Re: EPCOR Natural Gas Limited Partnership (“ENGLP”) EB-2018-0336 - Application for 2020 to 2024 Rates – Phase 2 Interrogatory Responses

1-STAFF-1 (Phase 2)

**EPCOR NATURAL GAS
SYSTEM MAP**

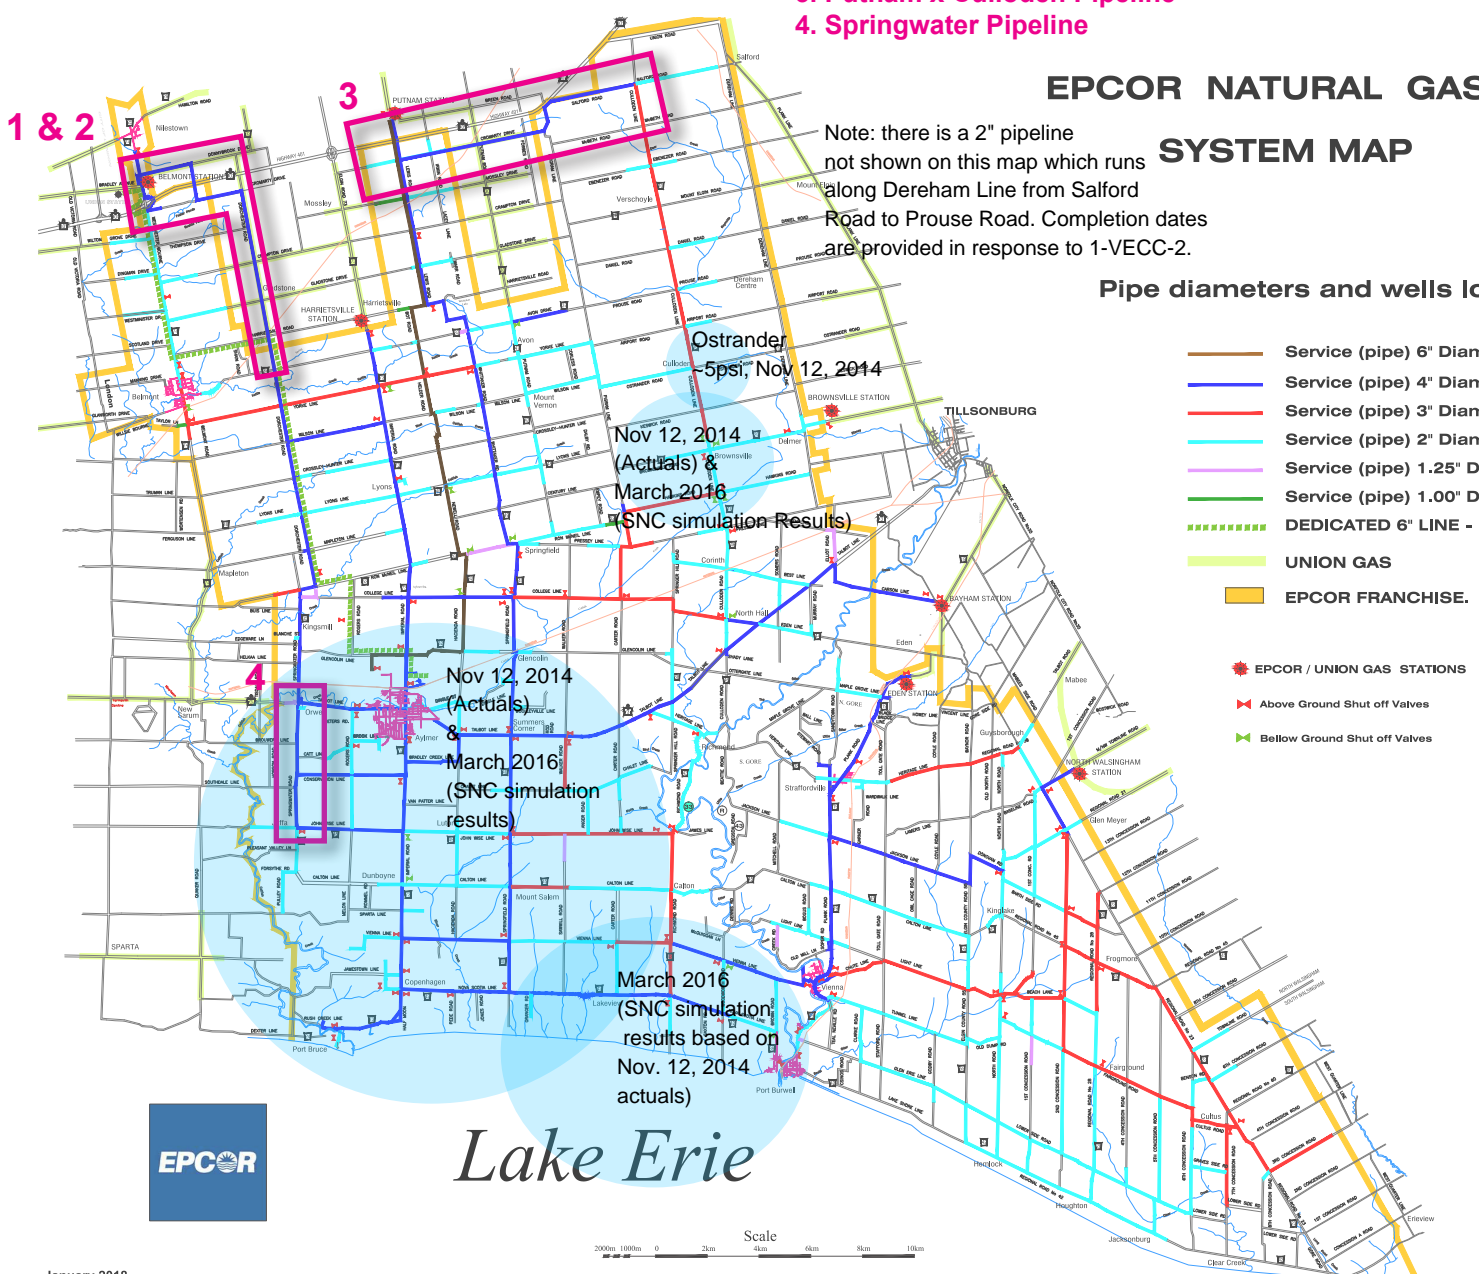
Please identify all areas of the system with low pressure. If possible, please provide a map identifying the low pressure areas.

ENGLP has provided a map indicating system pressure information prior to the implementation of the Four System Integrity Projects. The map also includes the (simulated) low pressure areas identified in the SNC-Lavalin Study in response to 1-Staff-7 (Phase 2), which employed high demand day pressure data from NRG from November 12, 2014. These maps are limited with respect to actual system measurements, as is the case with response to 1-Staff-7 (Phase 2).

Note: there is a 2" pipeline not shown on this map which runs along Dereham Line from Salford Road to Prouse Road. Completion dates are provided in response to 1-VECC-2.

Figure 1-Staff-3 – Route options (NRG’s implemented east then south route, and SNC’s south then east route) and the relative location of low pressure area around Brownsville depicted (bottom right)

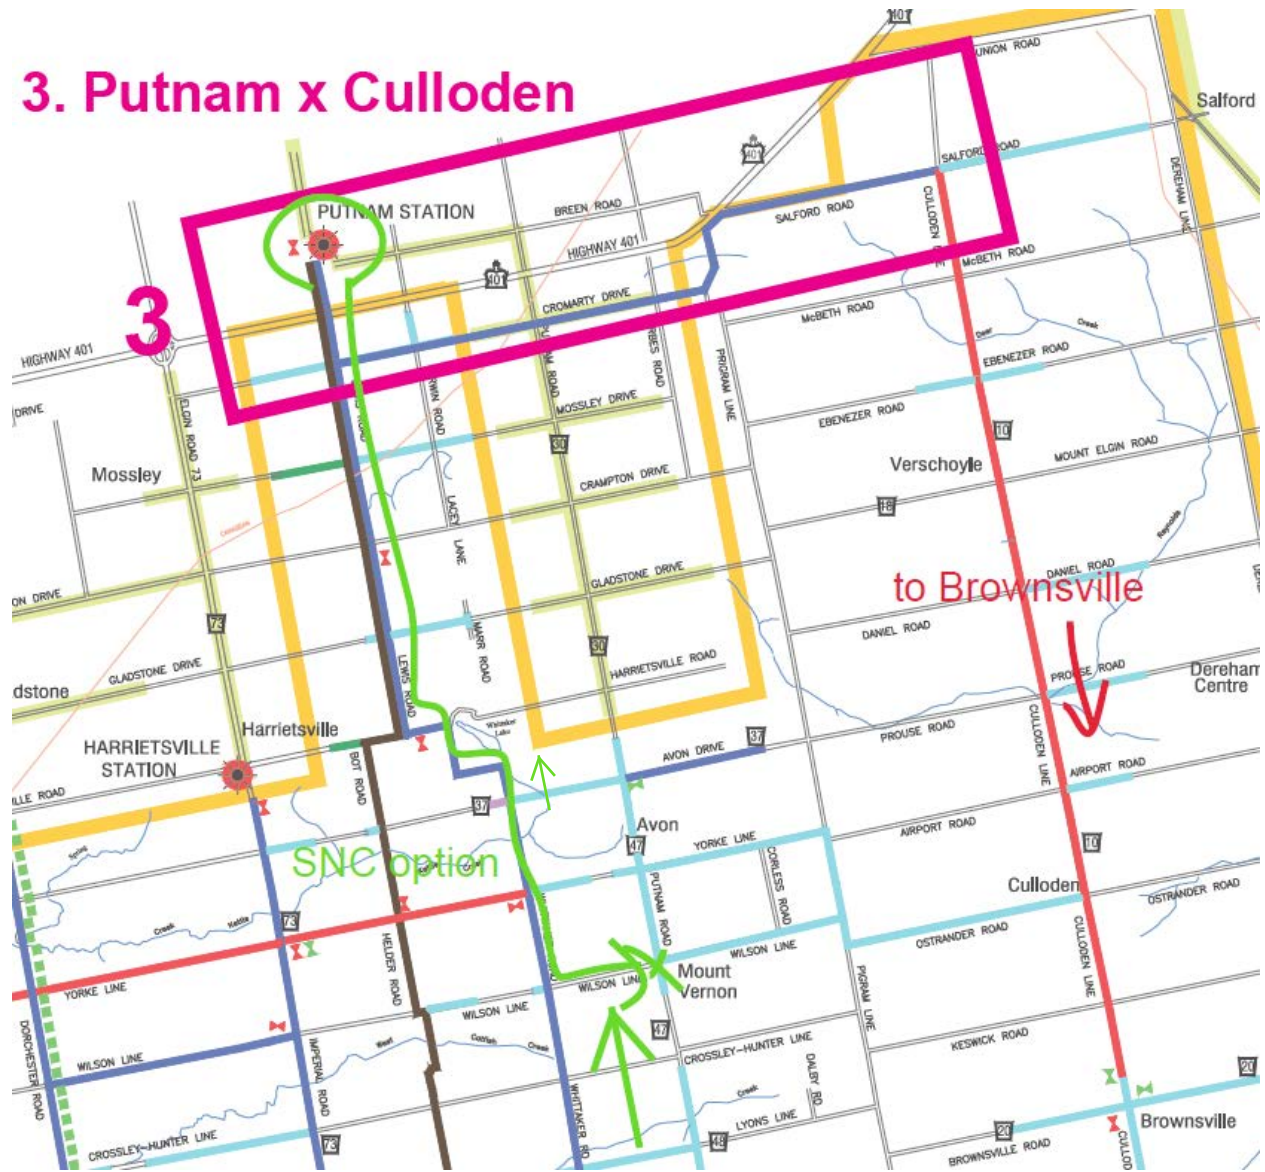
- a) The evidence states that SNC-Lavalin study did not examine the Putnam x Culloden pipeline. Why did SNC-Lavalin not examine the proposed pipeline from Putnam Station to the Culloden Line?
- b) What does the evidence mean by, "This benefit would not have been achieved with SNC's recommendation"?
- c) The benefits outlined in the evidence seem to indicate that it is a relief line (customers can be back-fed from the other direction) and refers to future benefits (ensure access to gas for new connections). What system integrity benefits did the Putnam x Culloden pipeline provide?
- d) What does the evidence mean by, "The solution implemented by NRG reflected more foresight and avoided a suboptimal investment"?

A map depicting the Putnam x Culloden pipeline and the alternative SNC option is attached to aid with understanding.

There is more than one plausible route to achieve the objective of delivering gas from Putnam station to the areas that were experiencing low pressure around Brownsville. The pipe distance from Putnam to Brownsville following the SNC-Lavalin option is marginally shorter than the Putnam x Culloden line that was implemented by NRG; however, the NRG path did not create a future 2" pipeline choke point on the system. Cornerstone's recommendations in their December 2018 report include investigating and resolving choke points, so avoiding creation of additional choke points, was likely a factor in NRG's routing decision. This is discussed in greater detail in part (d) of this interrogatory response.

- b) The SNC-Lavalin study recommended extending the Wilson Line pipeline from Putnam Road to Whitaker Road. Had this solution been implemented, customers on the Culloden Line pipeline north of Ostrander Road would be fed solely from the south. If a line strike or other failure were to occur on the Culloden Line pipeline between Ostrander Road and Ebenezer Road, any customers north of the failure would be interrupted.

- c) System integrity is inclusive of improvements to reliability for customers. The Putnam x Culloden pipeline allows gas from the Putnam Station to flow from west to east and into the Brownsville area with less restriction, addressing the low pressure issues identified around Brownsville. Modelling of the system completed in 2018 by Cornerstone, with the inclusion of the Putnam x Culloden pipeline, did not show low pressures in the Brownsville area and is consistent with the observations of operating staff.

- d) The SNC study recommended extending the Wilson Line pipeline from Putnam Road to Whitaker Road. This option would have tied the Lewis/Whitaker Road 4 inch pipeline to the Culloden Line 3 inch pipeline with a single 2 inch pipeline along Ostrander Road, creating a choke point. The Putnam x Culloden pipeline achieved the same objective of moving gas from Putnam Station from west to east and into the Brownsville area but avoided the choke point that a 2 inch pipeline may have created. It also provided the added benefit of looping the Culloden Line pipeline as discussed in part (b) of this interrogatory.
